BAYOU ISLAND SUBDIVISION

APPLICATION NUMBER 3 DATE September 1, 2005
APPLICANT Bayou Island Subdivision
REQUEST Subdivision

DETAIL SITE PLAN

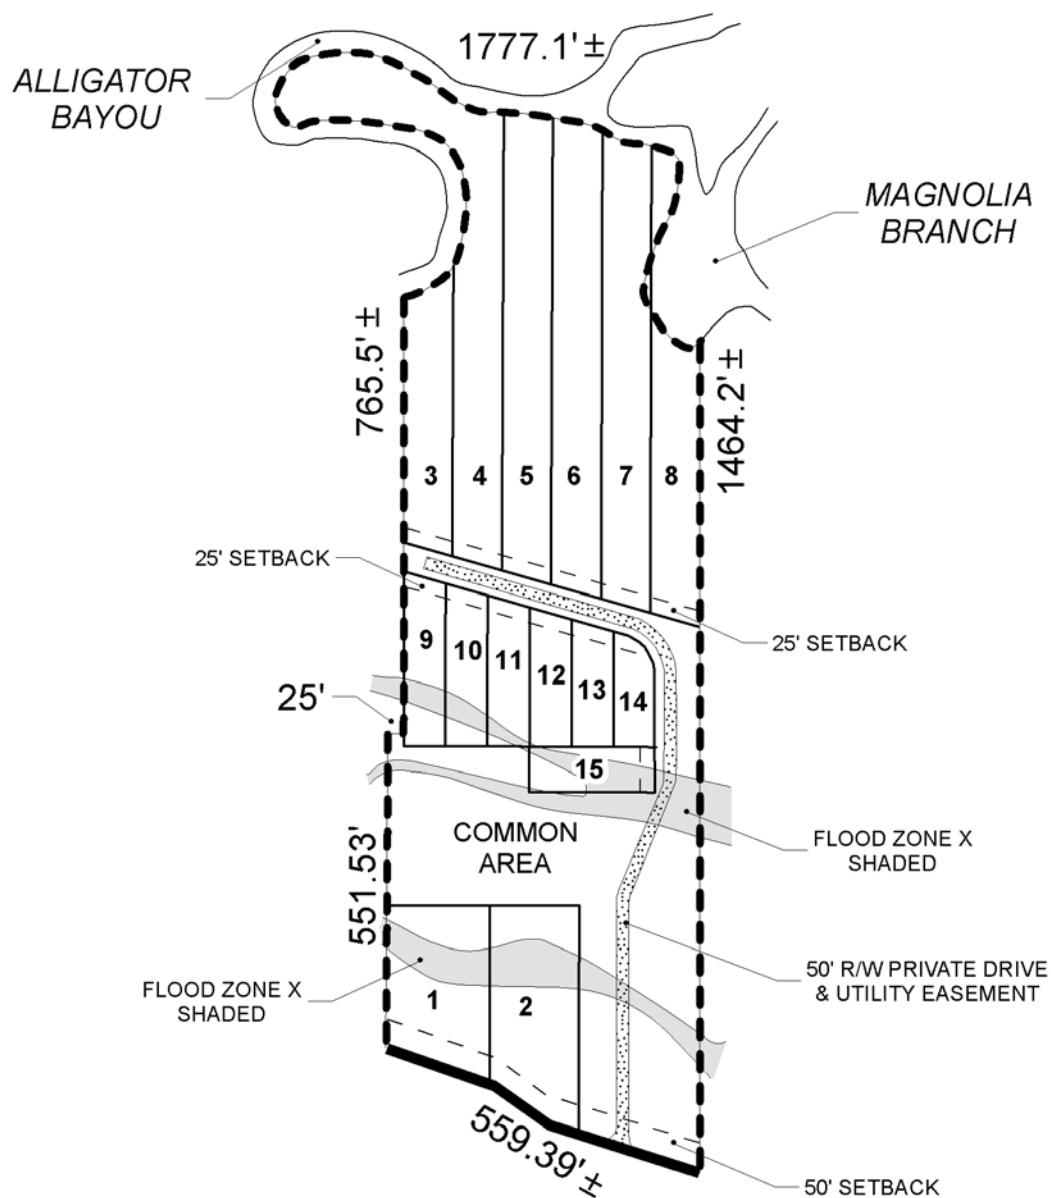
The site fronts Hamilton Boulevard, a planned major street. The current right-of-way width adjacent to the site varies, and in some cases appears to be less than the Major Street Plan recommended width of 100 feet. Therefore, the dedication of additional right-of-way to provide 50 feet from the centerline of Hamilton Boulevard should be required. The 25-foot minimum building setback lines depicted on the plat may need to be adjusted to reflect the dedication.

As the site fronts a major street, access management is a concern. The proposed subdivision will result in two lots with frontage on Hamilton Boulevard, and the remaining lots accessing Hamilton Boulevard via a private driveway. Lots 1 and 2, fronting onto Hamilton Boulevard, should be limited to one curb-cut each due to their limited frontage width. The proposed private driveway should be limited to one access point onto Hamilton Boulevard. The location, size, and design of any curb-cuts or driveway access points onto Hamilton Boulevard must be approved by County Engineering.

The design of the proposed subdivision shows a private “driveway” serving a minimum of 13 lots. The driveway will be approximately 1300 feet long, and as currently designed lacks a cul-de-sac at its terminus. Section V.B.6. of the Subdivision Regulations states that closed-end streets should generally not exceed 600 feet in length, and that they should have a turn-around at the termination point, unless it is anticipated that the street will be extended onto adjacent property. Previous applications with long cul-de-sac streets have been approved, provided an intermediate turn-around is provided around the 600-foot location as well as at the end of the street. The private “driveway” is labeled as a “50’ R/W Private Driveway and Utility Easement” on the plat, but is not actually depicted as a 50-foot wide right-of-way. Section VIII.E.2.c. of the Subdivision Regulations requires that private streets be provided as private rights-of-ways, rather than easements, to ensure accessibility to all properties that are to have access to the private street. Furthermore, the provision of a private right-of-way will clearly delineate the proposed “common area” from the “50’ R/W Private Driveway and Utility Easement.” Therefore if the subdivision is approved, the note on the plat should be revised to reflect the Subdivision Regulations’ requirements. Furthermore, the proposed private street must be built to the minimum standards listed in the Section.

The proposed subdivision will result in lots with a range of depth to width ratios, primarily due to the desire to provide frontage onto Alligator Bayou. Section V.D.3. of the Subdivision Regulations recommends a maximum depth to width ratio of 3.5 (depth is 3.5 times the width of the lot). Depth to width ratios for parcels in the area vary widely, and the area is potentially environmentally sensitive, thus a waiver of Section V.D.3. could be considered appropriate.

Finally, the legal description appears to have an error regarding the point of beginning for the site. Corrections should be included on the Final Plat, if approved.

With a waiver of Section V.D.3., the plat is recommended for Tentative Approval subject to the following conditions: 1) dedication of right-of-way sufficient to provide 50 feet from the centerline of Hamilton Boulevard, with adjustment of the 25-foot minimum building setback line as necessary; 2) placement of a note on the Final Plat stating that Lots 1 and 2 are limited to one curb cut each onto Hamilton Boulevard, and that the private driveway is limited to one access point onto Hamilton Boulevard, with curb-cut sizes, location and design to be approved by County Engineering; 3) approval of all applicable federal, state and local agencies regarding the wetlands and floodplain issues prior to the issuance of any permits; 4) placement of a note on the Final Plat stating that maintenance of all common areas is the responsibility of the property owners; 5) redesign of the proposed private driveway to provide intermediate and terminating turn-arounds, with adjustments in the right-of-way width as necessary, in conformance with Section V.B.6. of the Subdivision Regulations; 6) provision of a private right-of-way in conformance with Section VIII.E.2.c., and in order to delineate the common area from the private road; 7) placement of a note on the plat stating that the street is privately maintained and not dedicated to the public; 8) placement of a note on the plat stating that if the private street is not constructed and maintained to the appropriate Mobile County standard, and is ultimately dedicated for public use and maintenance, 100 percent of the cost of the improvements required to bring the street up to the prevailing standard shall be assessed to the property owners at the time the private street is dedicated, with the assessment running with the land to any subsequent property owners; 9) designation on the plat of utility easements acceptable to the appropriate provider of utility services within the subdivision, in conformance with Section VIII.E.2.d.; 10) placement of a note on the Final Plat stating that any lots which are developed commercially and adjoin residentially developed property must provide a buffer, in compliance with Section V.A.7. of the Subdivision Regulations; 11) provision of a legal covenant, in conformance with Section VIII.E.2.f. of the Subdivision Regulations; 12) provision of a street sign in conformance with Section VIII.E.2.i. of the Regulations, and; 13) correction of the Legal Description's point of beginning reference.
